PROJECT NAME: Woodlawn Baptist Church

SITE PLAN: SP-2010-0158C

REQUEST: The applicant is appealing the denial of an administrative

MEMORANDUM

Fxhibit # 1

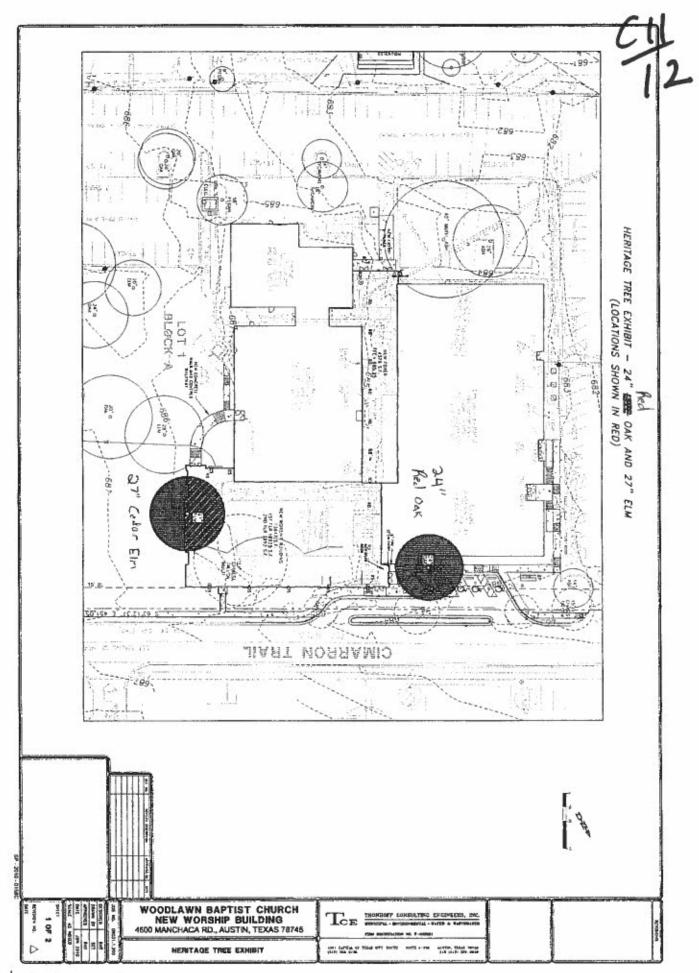
Two heritage size trees are proposed to be removed. The subject trees are a 27" dbh Cedar Elm (*Ulmus crassifolia*) located just within the footprint of the proposed worship hall and a 24" non-native Red Oak (*Quercus spp.*) located within the footprint of the proposed parking spaces (Exhibit 1).

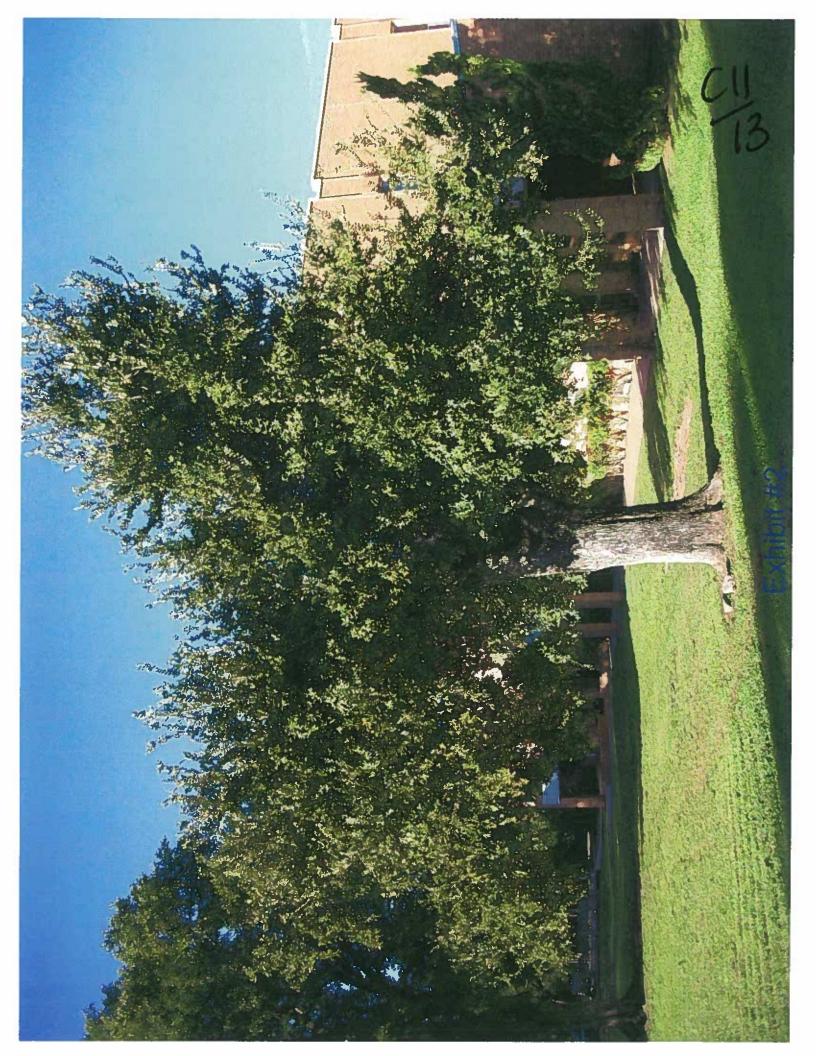
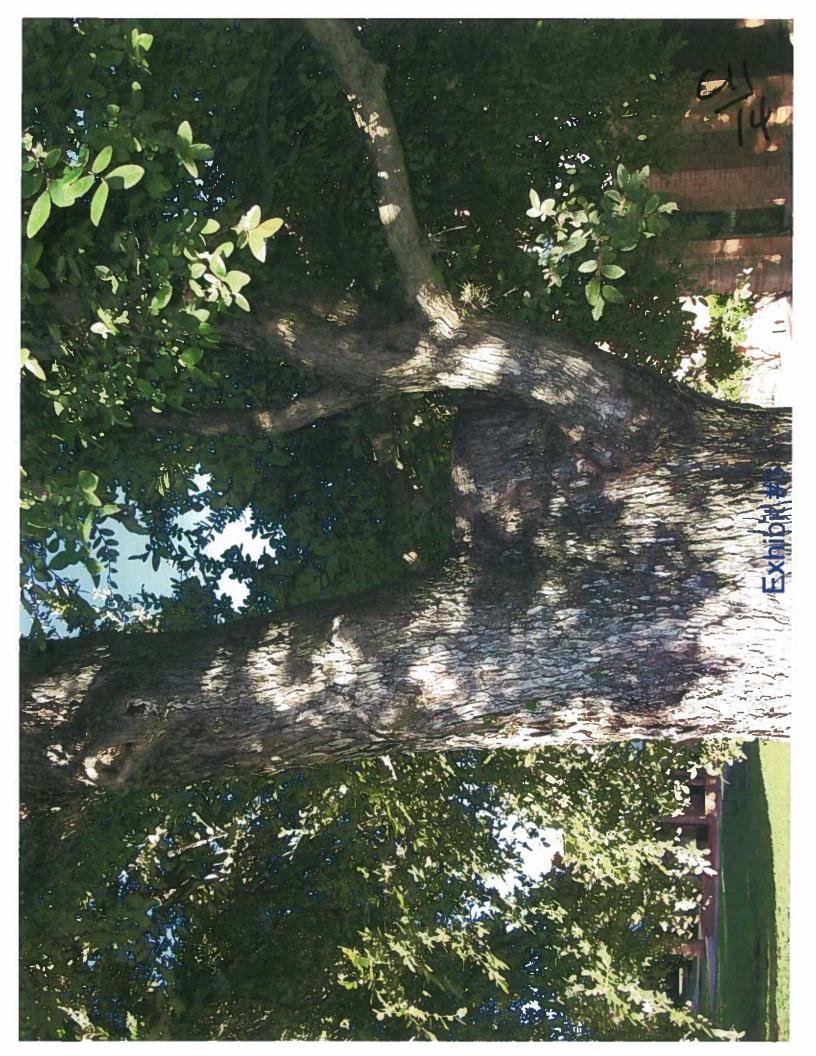
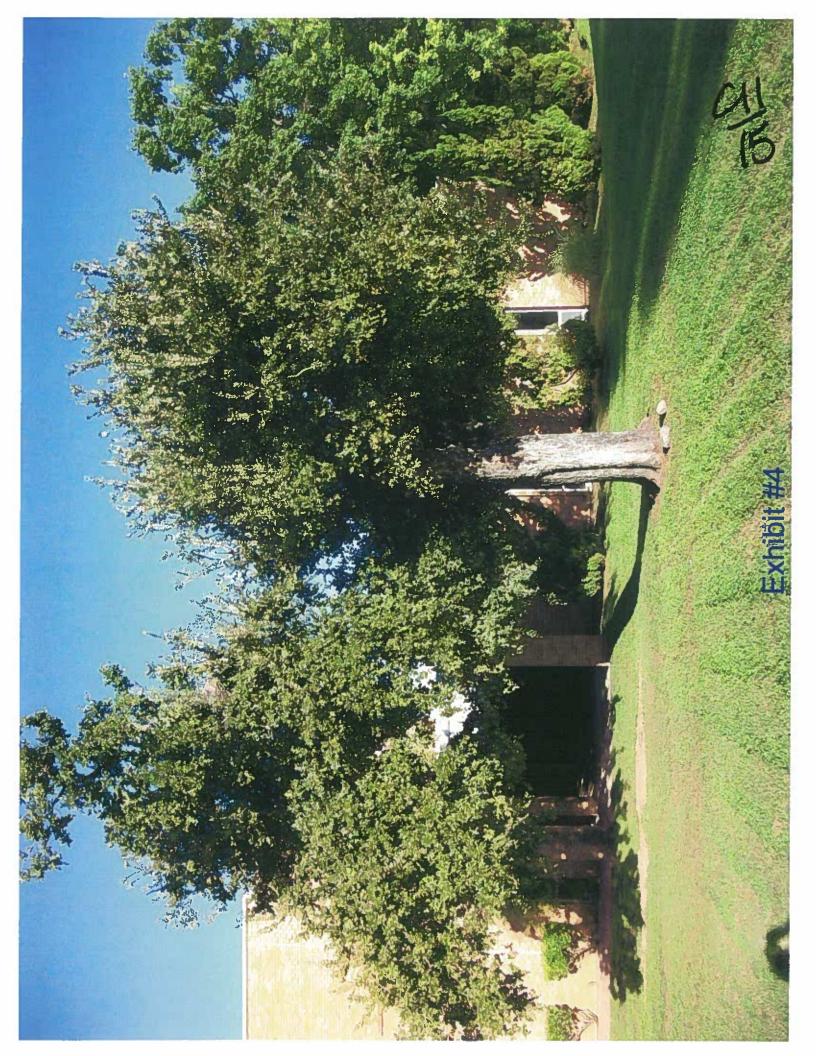
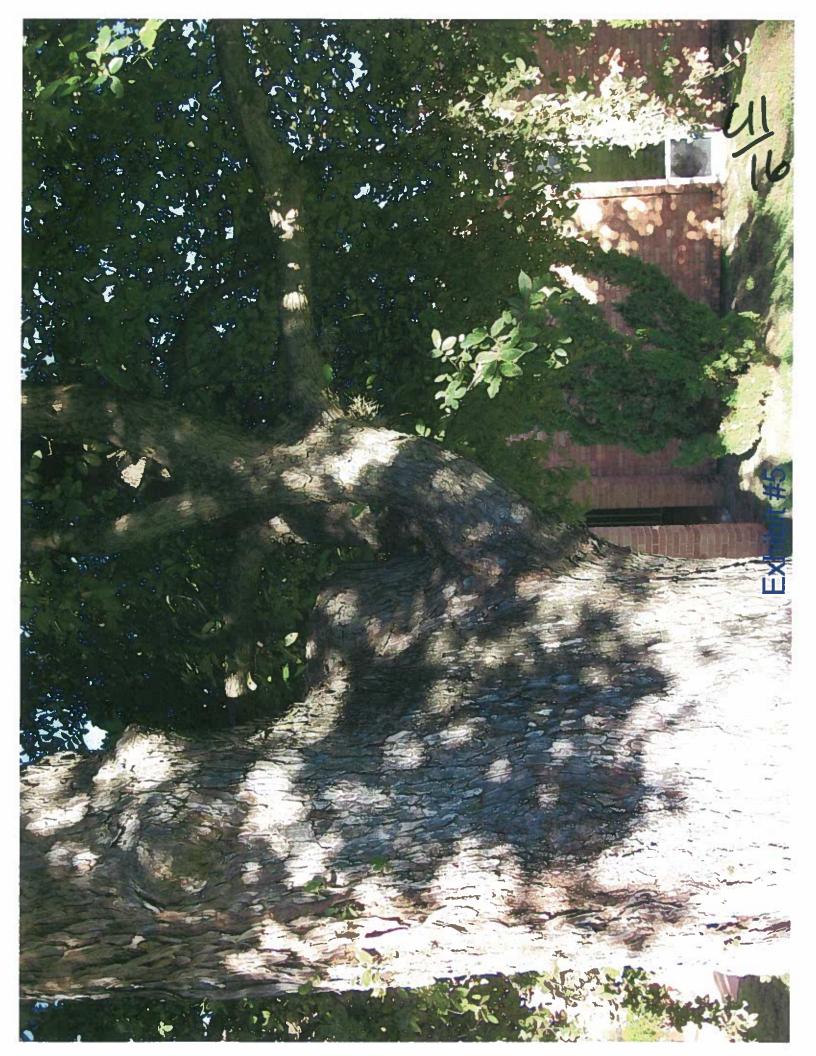
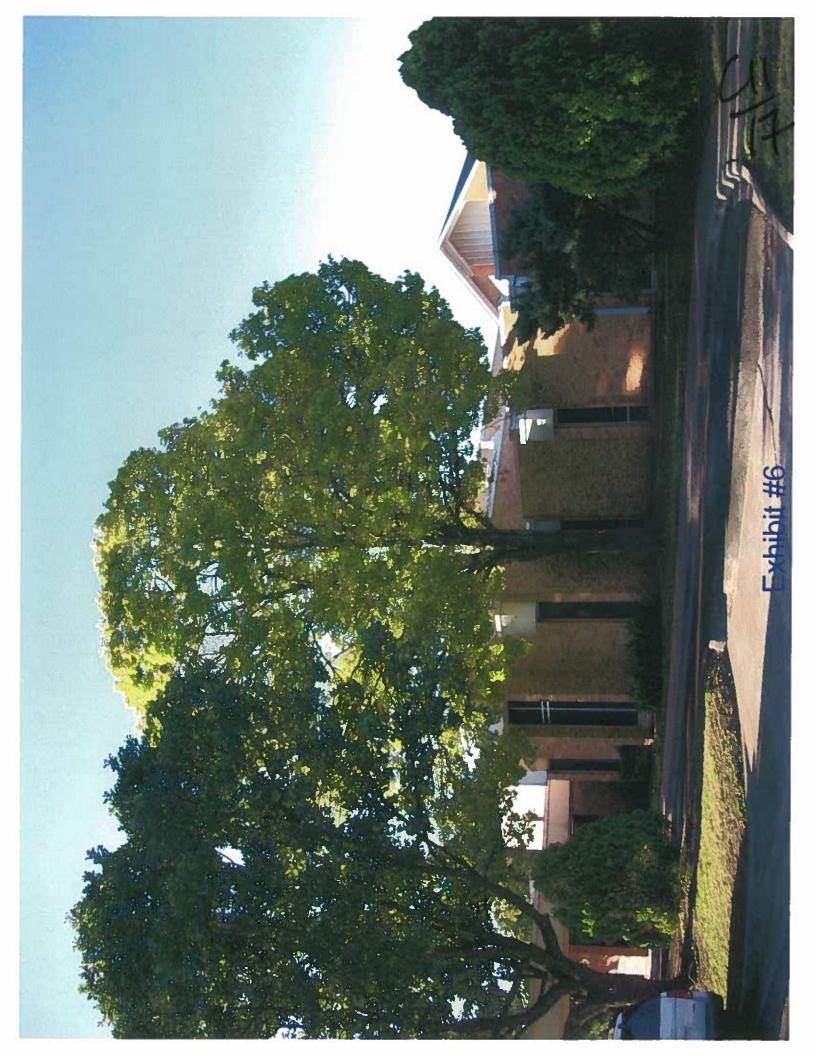
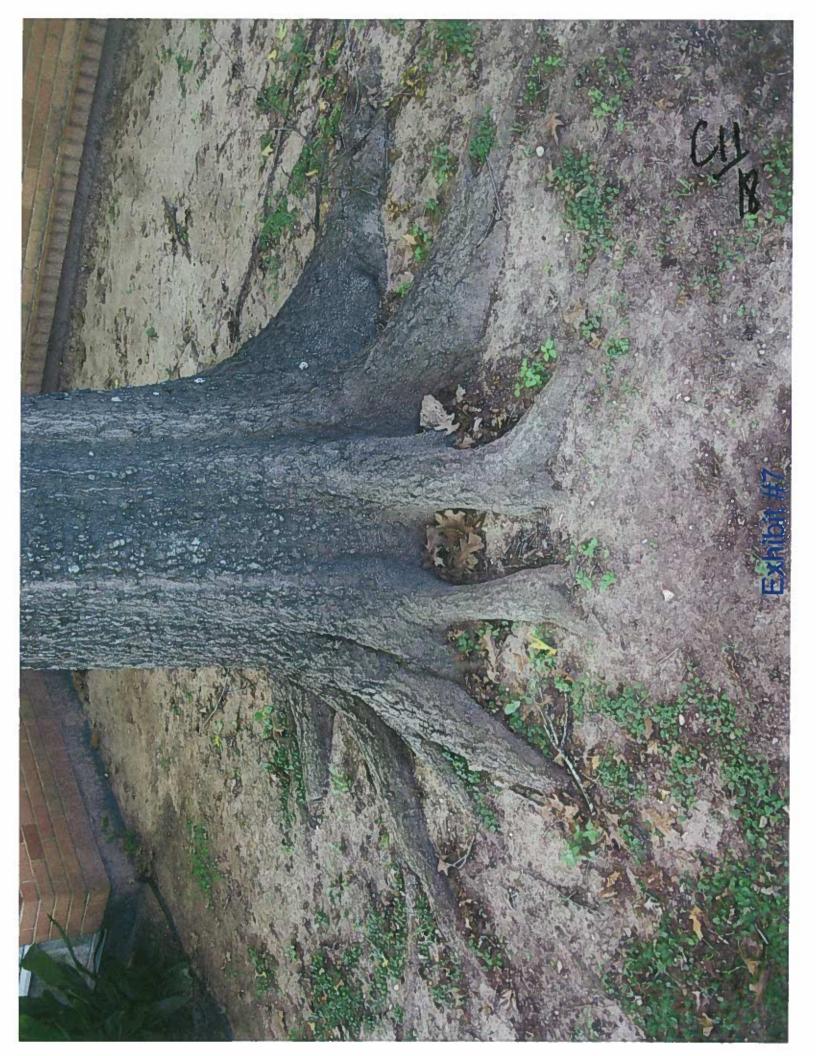
Based on a September 28, 2010, tree assessment, the 27" Cedar Elm displays severe structural defects. The main leader of the subject tree is no longer present (Exhibit 2). This defect is likely due to either storm damage or improper pruning. Further, at some point in the past the subject tree likely had two stems, possibly codominate. One of the stems is no longer present (Exhibit 3). This defect is also likely due to either storm damage or improper pruning. The absence of a main leader has resulted in lateral bud growth and an imbalanced canopy (Exhibit 4). This has further exacerbated the structural weakness of the tree already weakened by decay and poorly attached adventitious stems (Exhibit 5).

Based on a September 28, 2010, tree assessment the 24" Red Oak (Quercus spp.) was identified as a Red Oak displaying severe symptoms of foliar chlorosis (Exhibit 6). This tree has likely suffered from chronic chlorosis due in part to soil compaction (Exhibit 7) and calcareous soils, but more so from a poor choice in species selection as this species or cultivar of Red Oak does not appear to be a native species based on analysis of the leaf morphology. The subject tree appears to be either (1) a cultivar of *Quercus shumardii* or (2) a species of red oak from the southeastern United States. Either way, the tree species is likely adapted to more acidic soils than the existing soil conditions.

Staff recommends, with condition, approval of the variance request given the defects of the subject trees. The condition is:

1. 150% mitigation for both trees given their respective conditions.
